National TAB
1329 E. KEMPER ROAD
SUITE 4210
CINCINNATI, OH 45246

Report: TAB Report
Function: Test, Adjust, & Balance
Date: 09/23/2025
Completed By: National TAB

09-22-25 WAWA #6625 LYNCHBURG, VA

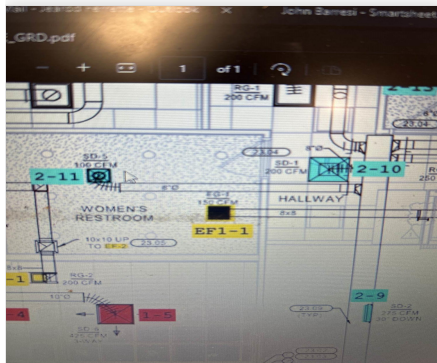
Issue Name : Missing women's restroom damper
Description : Woman's supply damper/ face damper missing. Currently at 275% off design.
Created By : National TAB **Assigned To :** National TAB - Brianna Biggs
Status : Open
Priority : Low **Asset Tag :** SGRD11
Originated Date : 09/23/2025 - Jearod Ferrette - National TAB

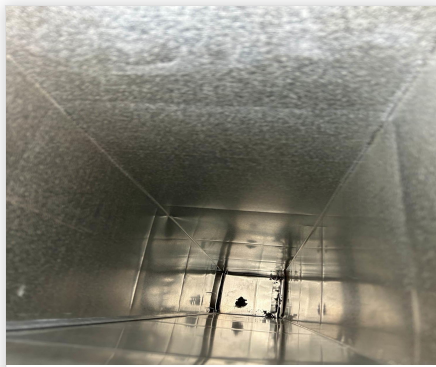
Issue Name : RTU 1 electric heater missing
Description : The electric heater is missing inside the unit.
Created By : National TAB **Assigned To :** National TAB - Brianna Biggs
Status : Open
Priority : High **Asset Tag :**
Originated Date : 09/22/2025 - Jearod Ferrette - National TAB

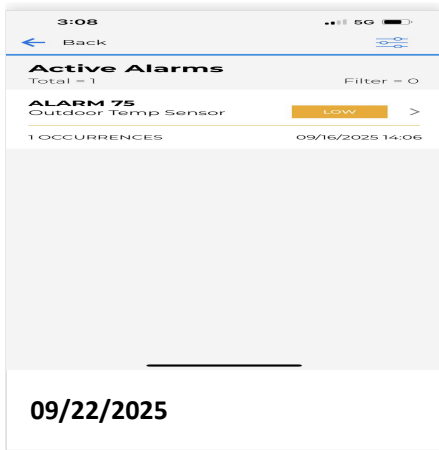
Issue Name : RTU 2 in alarm
Description : RTU 2 in alarm
Created By : National TAB **Assigned To :** National TAB - Brianna Biggs
Status : Open
Priority : Medium **Asset Tag :** RTU2
Originated Date : 09/22/2025 - Jearod Ferrette - National TAB

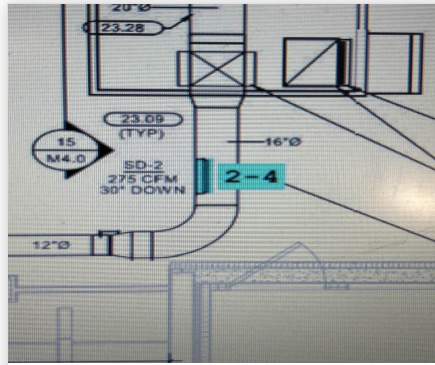
Issue Name : RTU 2 short 1 diffuser
Description : RTU 2 SGRD2-4 not installed on ductwork. Unit short 1 supply diffuser.
Created By : National TAB **Assigned To :** National TAB - Brianna Biggs
Status : Open
Priority : Medium **Asset Tag :** SGRD4
Originated Date : 09/22/2025 - Jearod Ferrette - National TAB

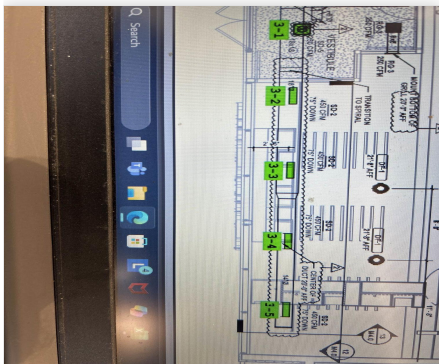
Issue Name : RTU 3 dampers inaccessible
Description : RTU 3 diffusers 3-1 & 3-5 are inaccessible with lift/ladder. Unit currently at total flow.
Created By : National TAB **Assigned To :** National TAB - Brianna Biggs
Status : Open
Priority : InfoOnly **Asset Tag :**
Originated Date : 09/22/2025 - Jearod Ferrette - National TAB

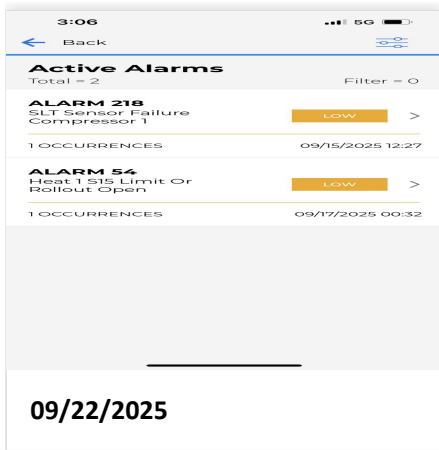
Issue Name : RTU 3 in alarm
Description : RTU 3 in alarm
Created By : National TAB **Assigned To :** National TAB - Brianna Biggs
Status : Open
Priority : Medium **Asset Tag :** RTU3
Originated Date : 09/22/2025 - Jearod Ferrette - National TAB
